NRC RAI

Response L-0998 Outline:

Levy Nuclear Plant Units 1 and 2
COL Application
Part 2, Final Safety Analysis Report

Figure RAI L-0998-2: Comparison of scaled GMRS based on EPRI-SOG/UCSS model with full CAV with the GMRS based on the CEUS SSC model with modified CAV

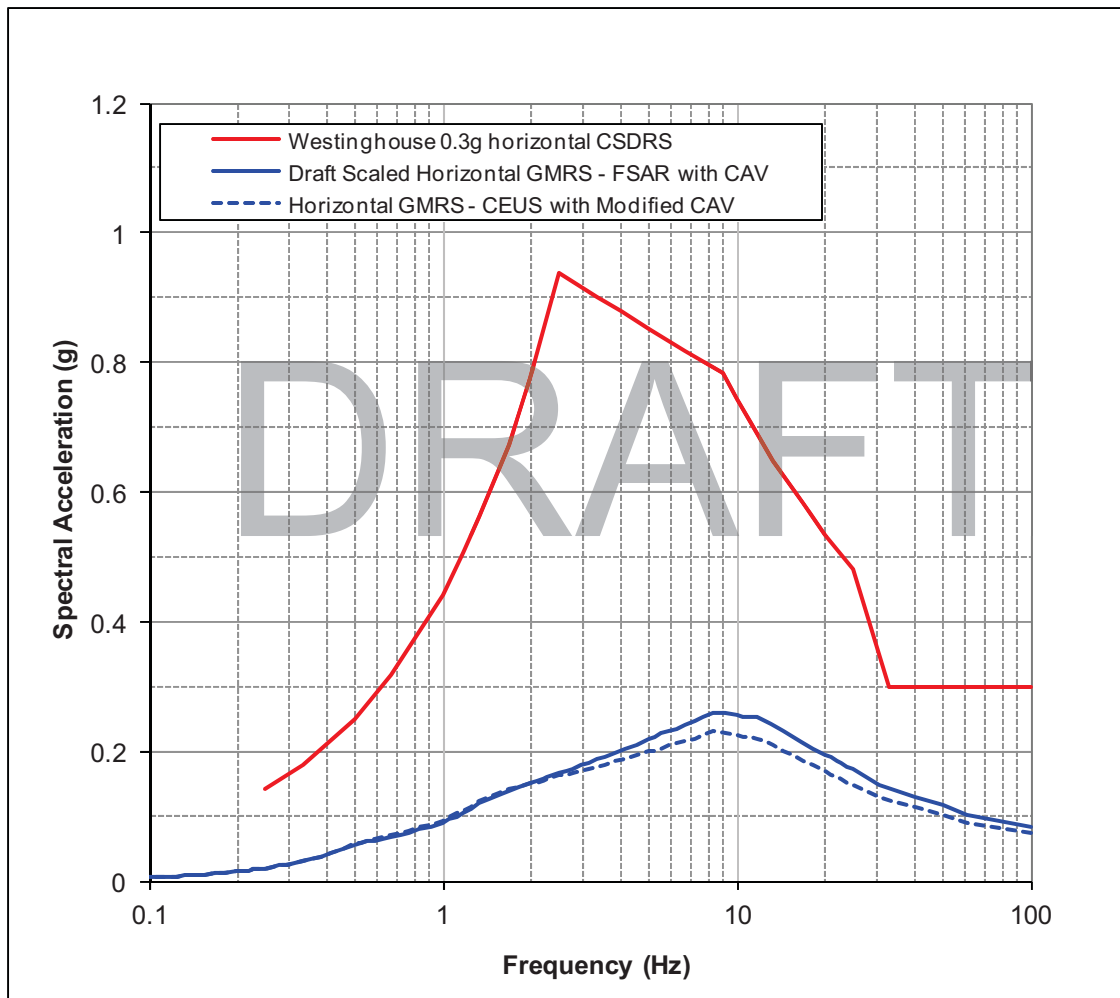
Figure RAI L-0998-2 compare the scaled GMRS based on the EPRI-SOG/UCSS model with full CAV with the GMRS based on the CEUS SSC model with modified CAV. The scaled GMRS based on the CEUS SSC is lower than the GMRS based on the EPRI-SOG/UCSS model with full CAV except for frequencies between 0.2 and 2 Hz where the maximum increase is approximately 4 percent at 1 Hz.

Figure RAI L-0998-3: Comparison of PBSRS based on EPRI-SOG/UCSS model with full CAV with the PBSRS based on the CEUS SSC model with modified CAV

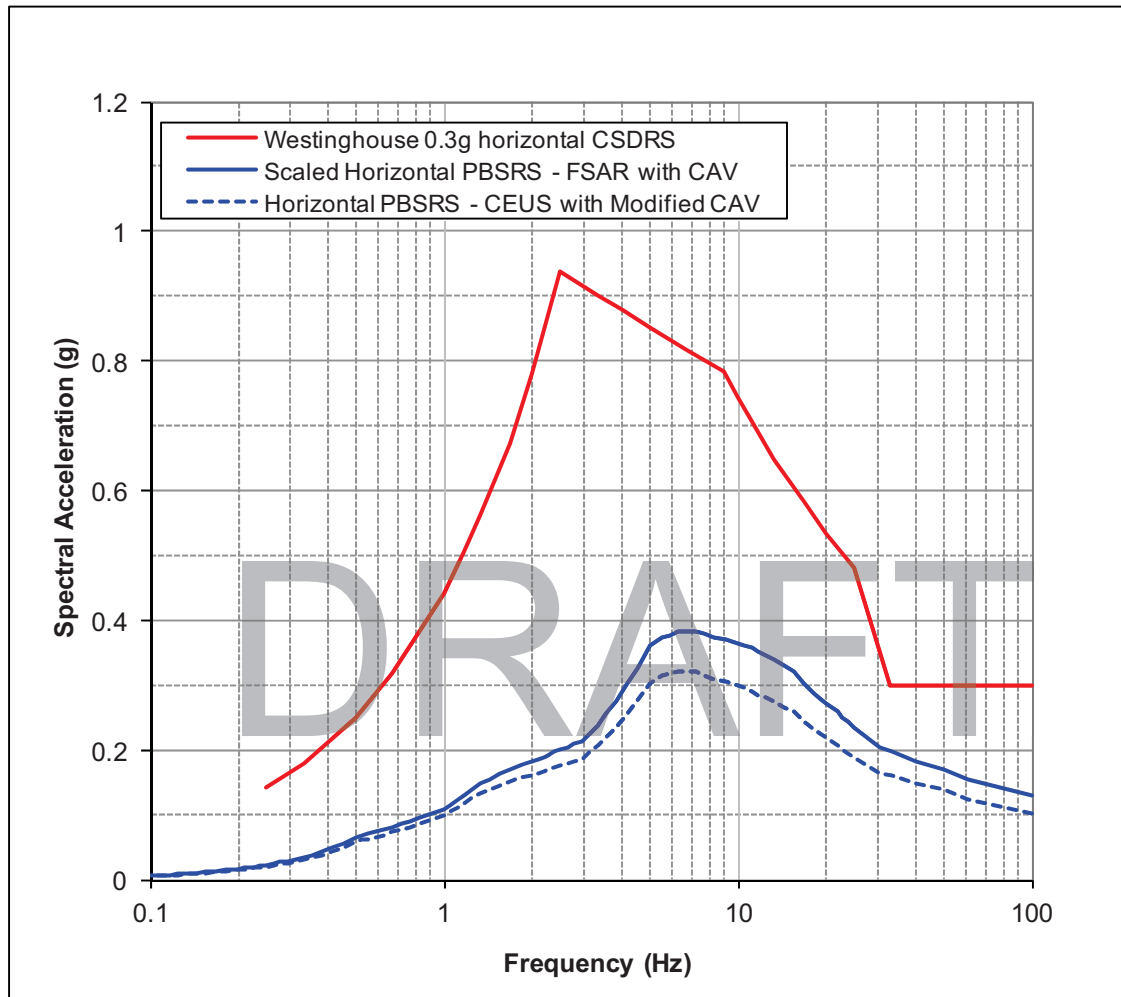
Figure RAI L-0998-3 compares the scaled PBSRS based on the EPRI-SOG/UCSS model with full CAV with the PBSRS based on the CEUS SSC model with modified CAV. The PBSRS based on the CEUS SSC model is enveloped by the scaled PBSRS based on the EPRI-SOG/UCSS model at all frequencies,

Figure RAI L-0998-5: Comparison of RB FIRS (+11 ft) based on EPRI-SOG/UCSS model with full CAV with the RB FIRS based on the CEUS SSC model with modified CAV

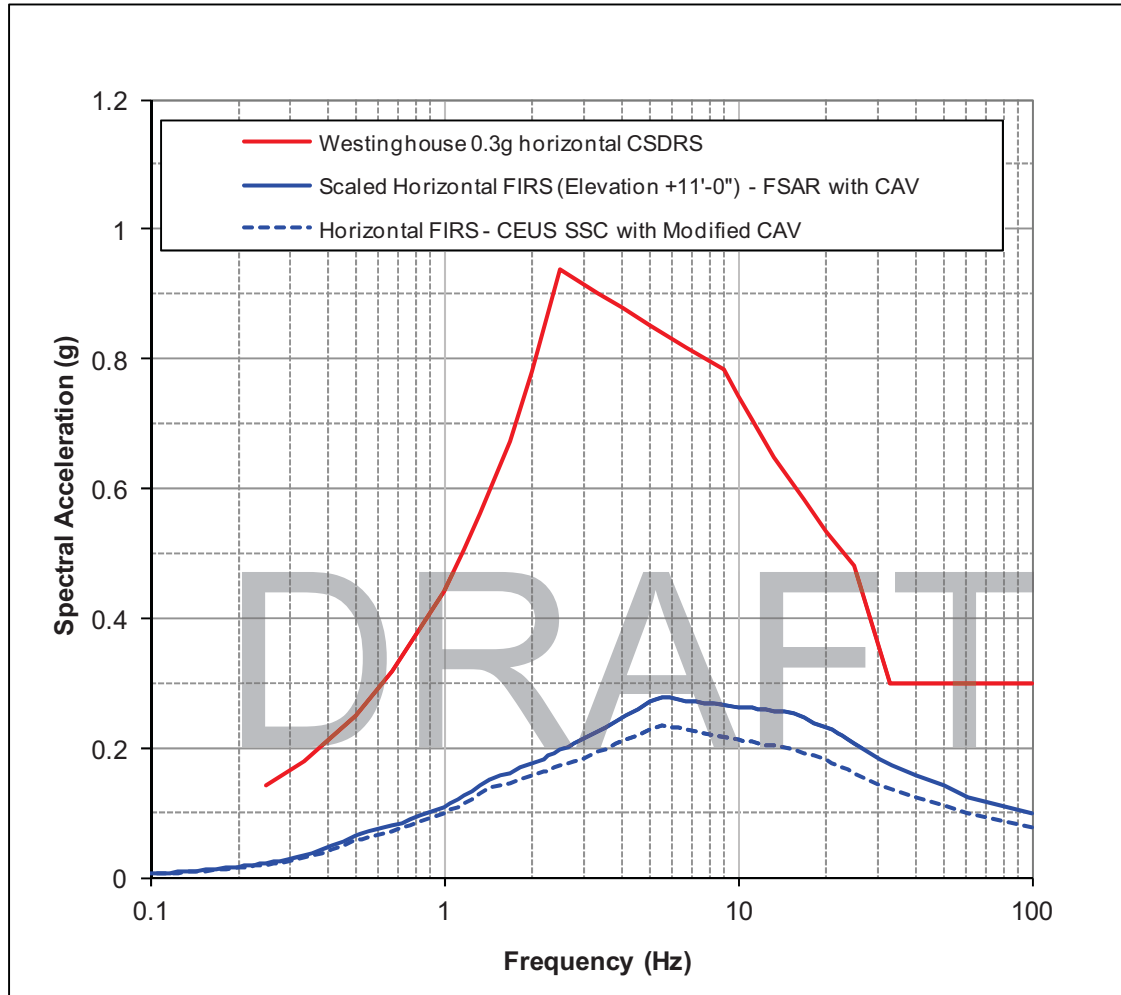
Figure RAI L-0998-5 compares the scaled Reactor Building FIRS based on the EPRI-SOG/UCSS model with full CAV with the Reactor Building FIRS based on the CEUS SSC model with modified CAV. The Reactor Building FIRS based on the CEUS SSC model is enveloped by the scaled Reactor Building FIRS based on the EPRI-SOG/UCSS model at all frequencies.

Figure RAI L-0998-6: Comparison of the horizontal 10^{-5} UHRS at finished grade developed using the EPRI-SOG/UCSS source model presented in the FSAR with 1.67 x the GMRS developed using the CEUS SSC model with modified CAV.

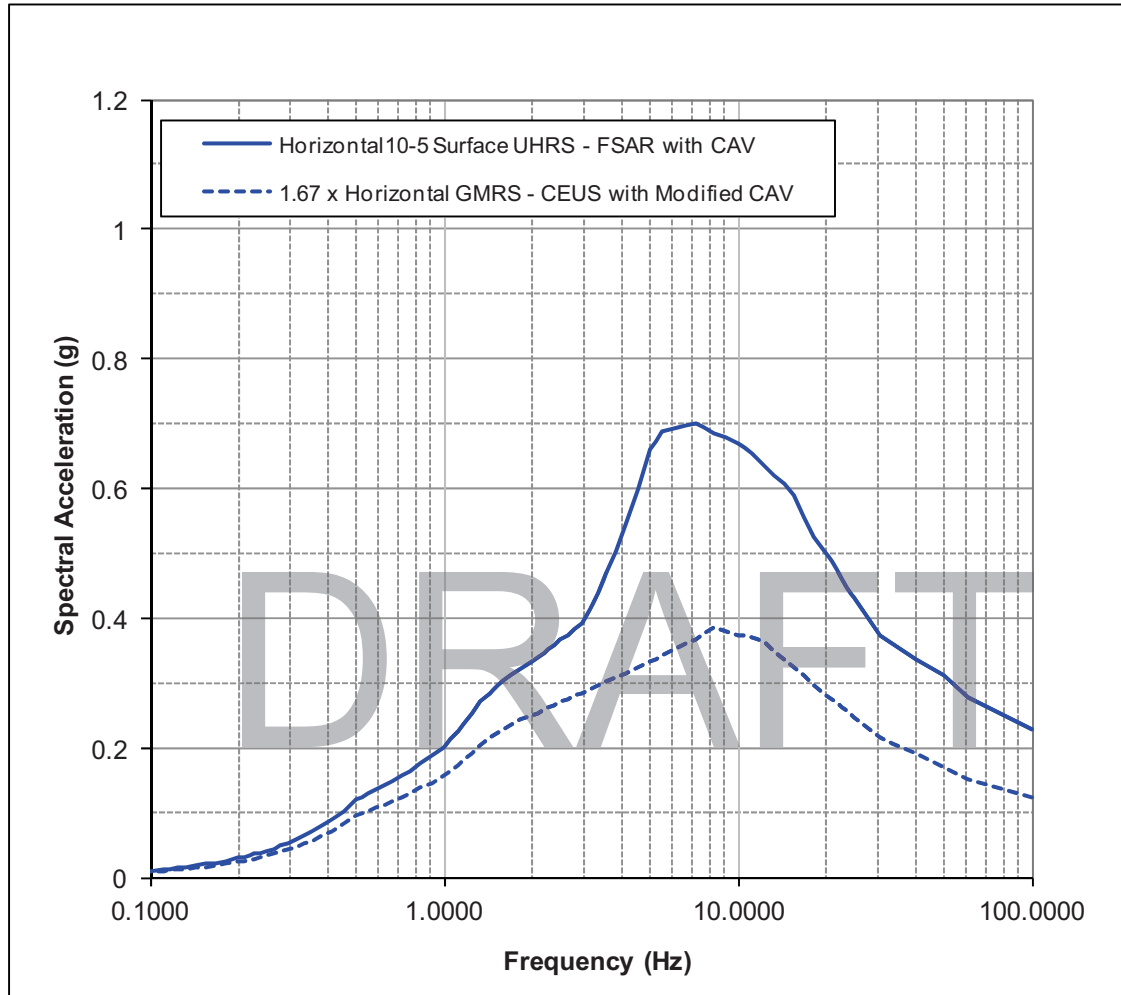
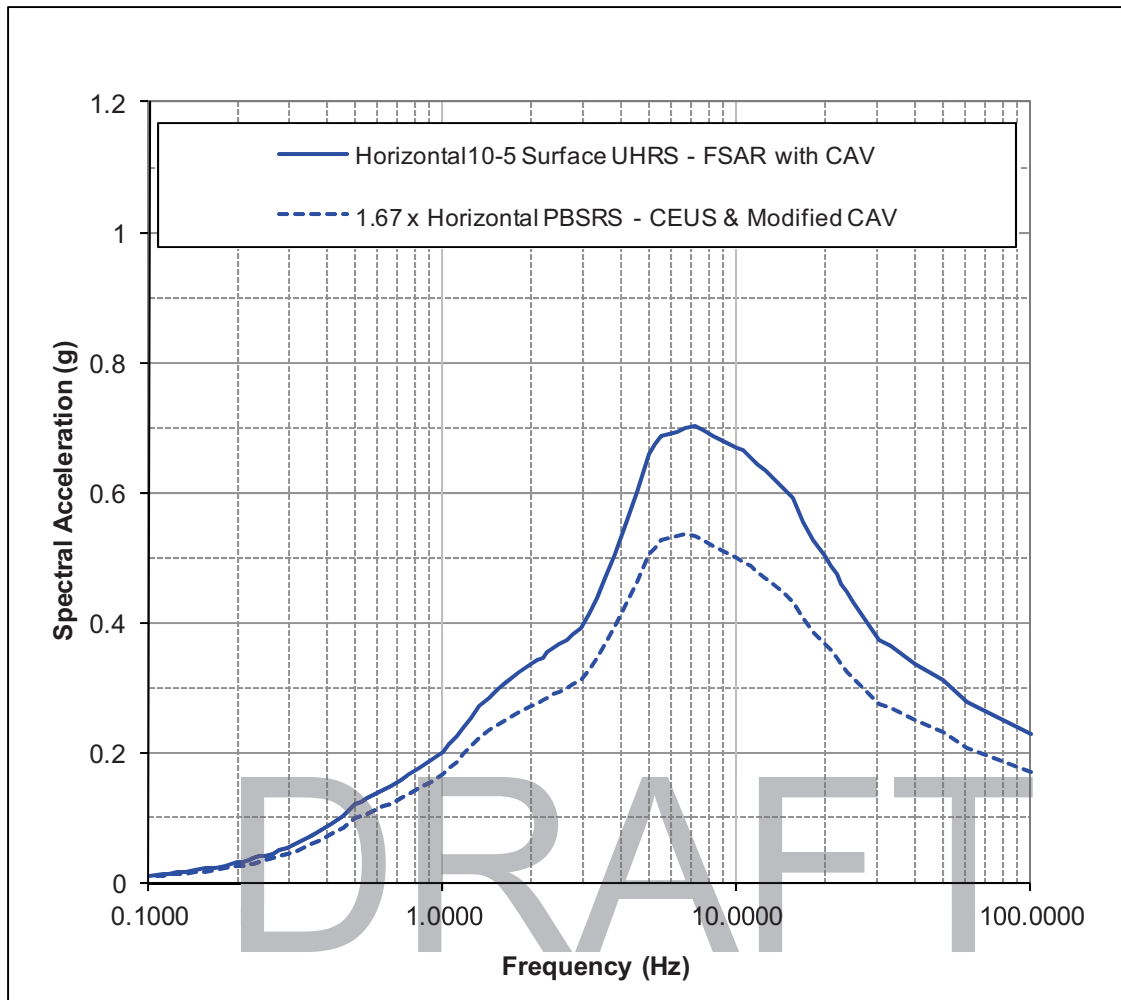
Figures RAI L-0998-6 and -7 compare the 10^{-5} horizontal surface UHRS based on the EPRI-SOG/UCSS model with full CAV to 1.67 x the GMRS and PBSRS, respectively, based on the CEUS SSC model with modified CAV. The 1.67 x the GMRS and PBSRS based on the CEUS SSC model with modified CAV are enveloped by the 10^{-5} horizontal surface UHRS based on the EPRI-SOG/UCSS model with full CAV.
